# M5 Junction 10 Improvements Scheme

**Statement of Common Ground  
Environment Agency  
TR010063 – APP 8.4**

#### 8.3 Statement of Common Ground Environment Agency

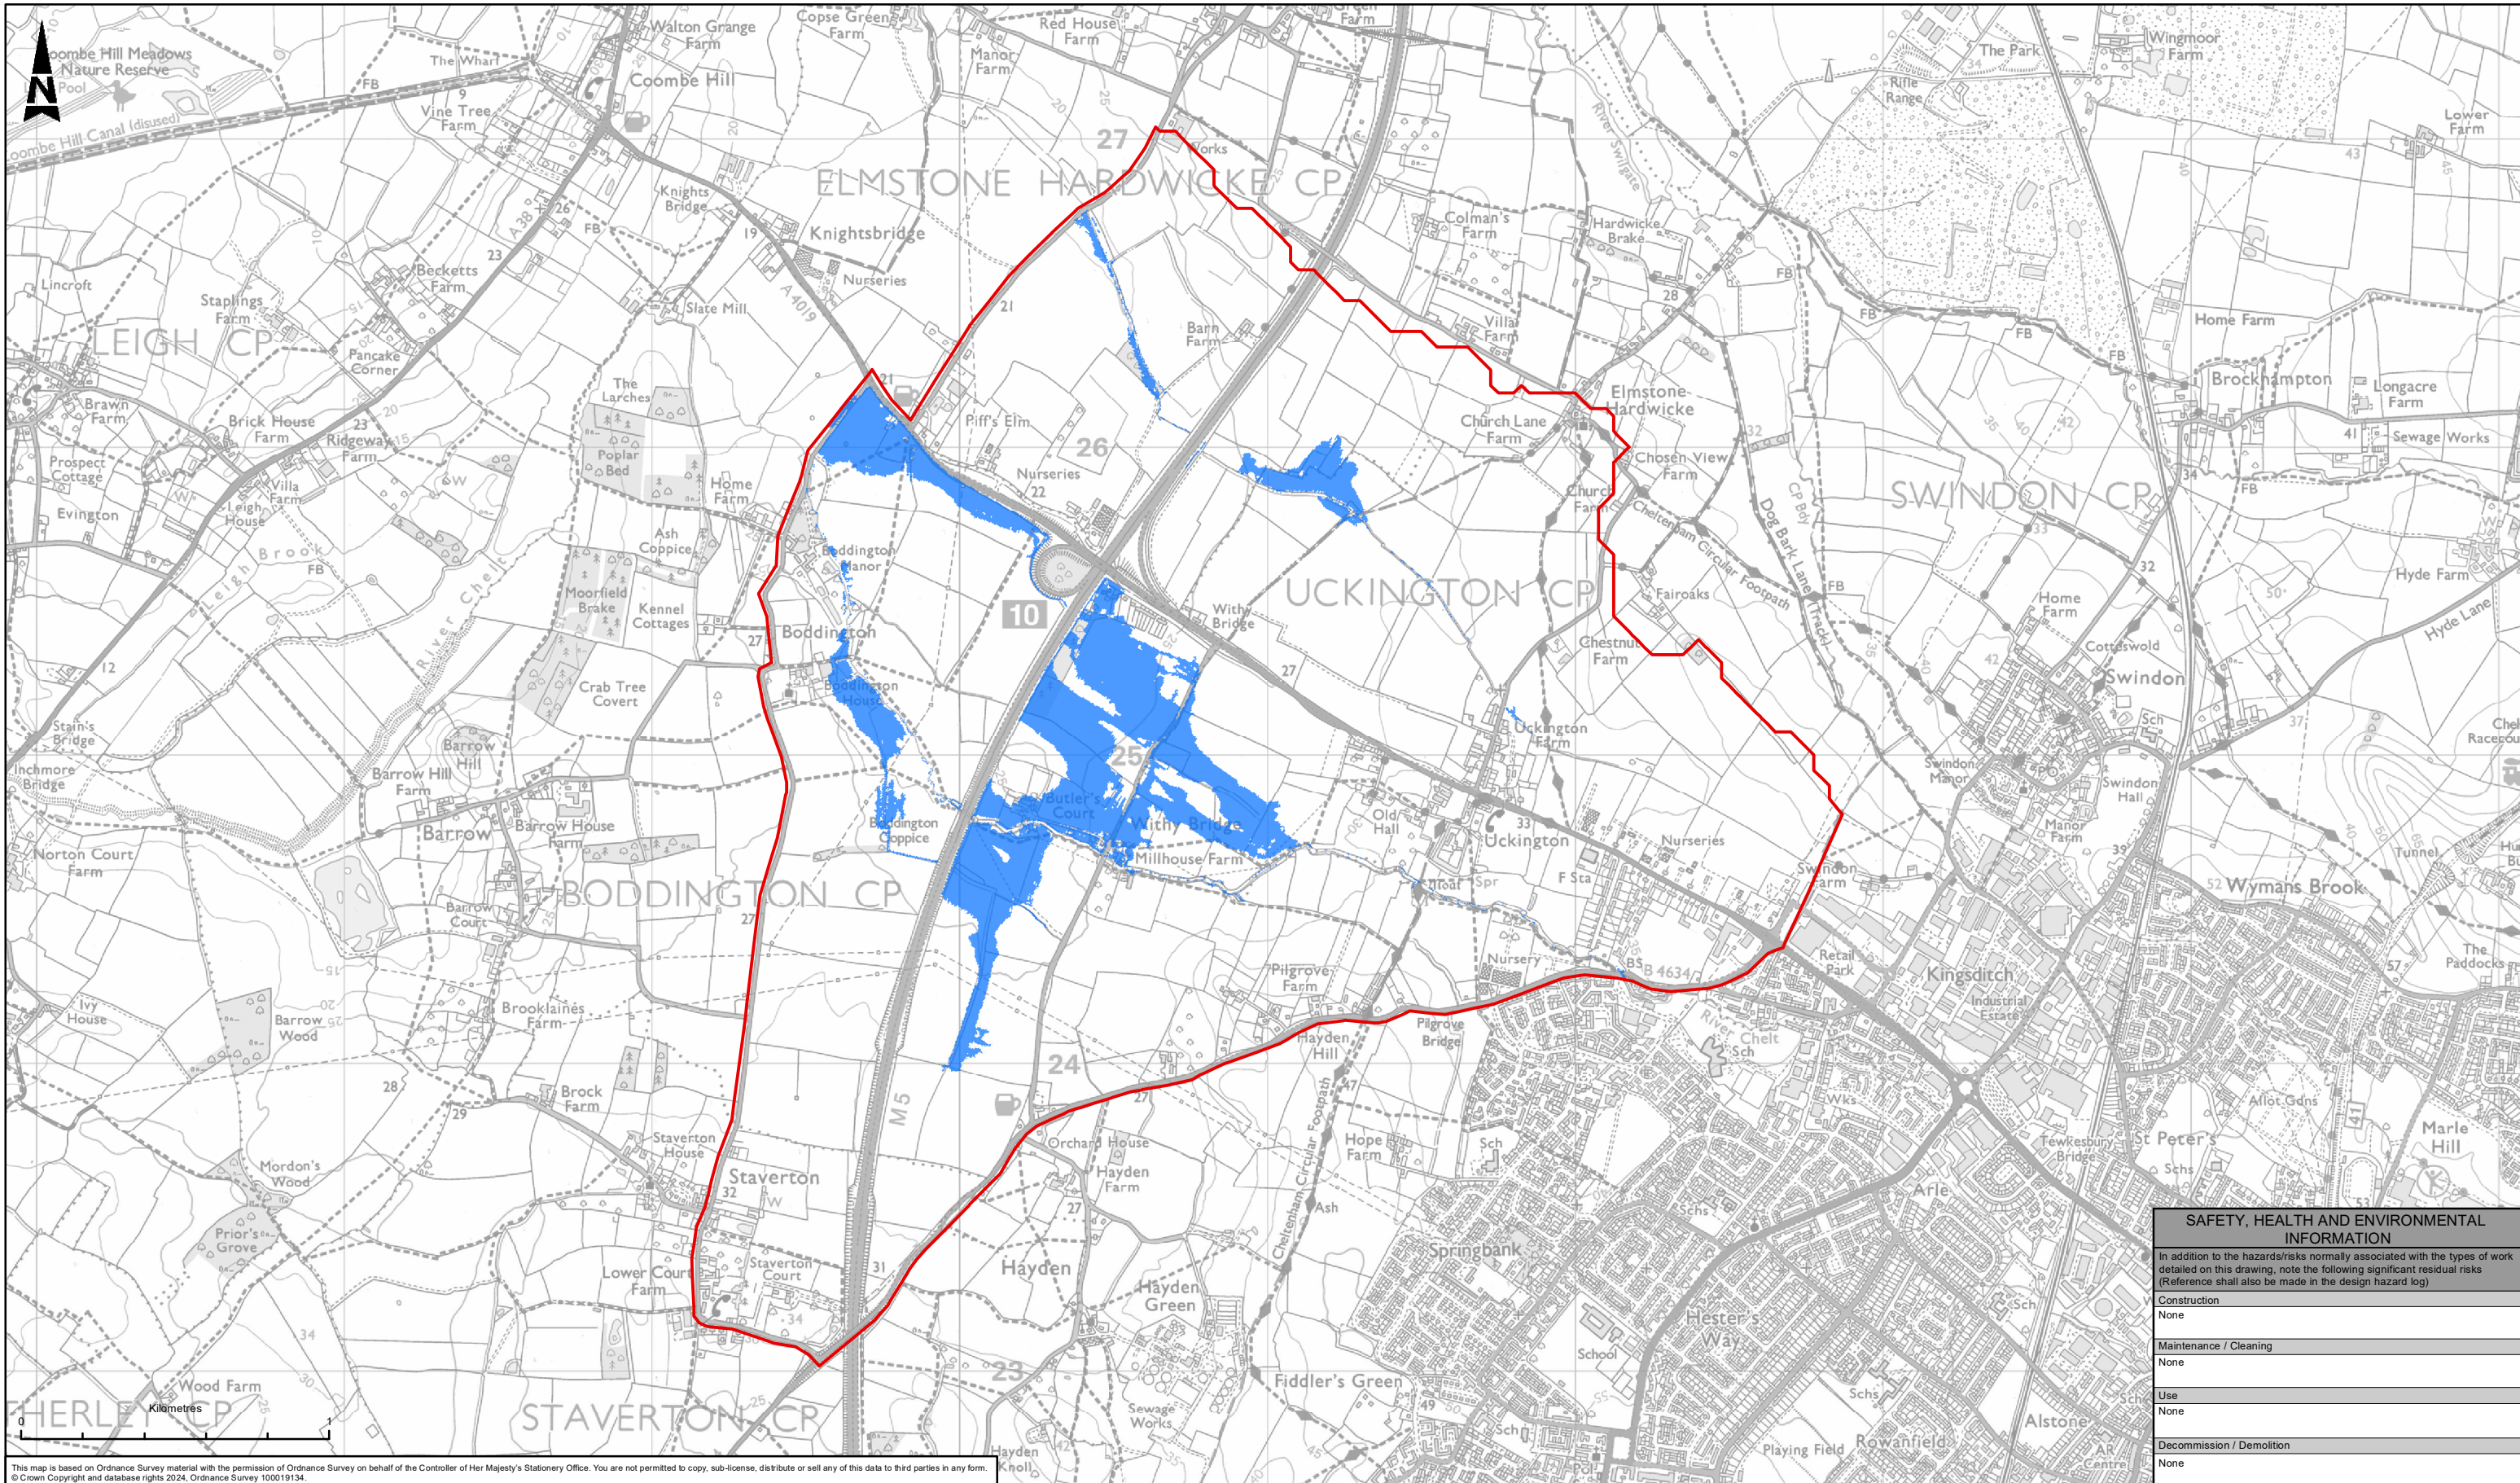
8.7.	Any solution for the crossing of the Link Road through the Chelt flood plain as highlighted in sections 5.4.42 to 5.4.48 of the PEIR FRA, should take account of the extents of Flood Zone 3b, where an open viaduct structure should be considered to meet the avoidance principles set out in table 5.1 (PEIR FRA).	The Link Road structures are described in the Scheme modelling report (issued March 2022). Testing has been undertaken to evaluate the size of conveyance structures and optimise the balance between a zero afflux structure and something smaller and its adverse impacts upstream. This follows the hierarchy of flood risk management taking into account the wider social, environmental and economic factors in the design. Further testing was undertaken to establish the location of the floodplain	24.06.2024 EA to review FZ3b figure following Deadline 1.

Matters Reference Number	Position of Interested Party	Response	Date of the last position
		<p>crossing in relation to the overland flow paths.(12.05.2023)</p> <p>24.06.2024</p> <p>The Applicant has appended the Flood Zone 3b figure within Appendix A of this document.</p>

- A.1.4. We have now applied the 3.3% annual exceedance probability event (1 in 30-year return period) event to the model to specifically identify the floodplain equivalent to the updated FZ3b. This is indicated in the figure below – see Figure 1: Flood Zone 3b (3.3% annual exceedance probability event (1 in 30-year return period)).
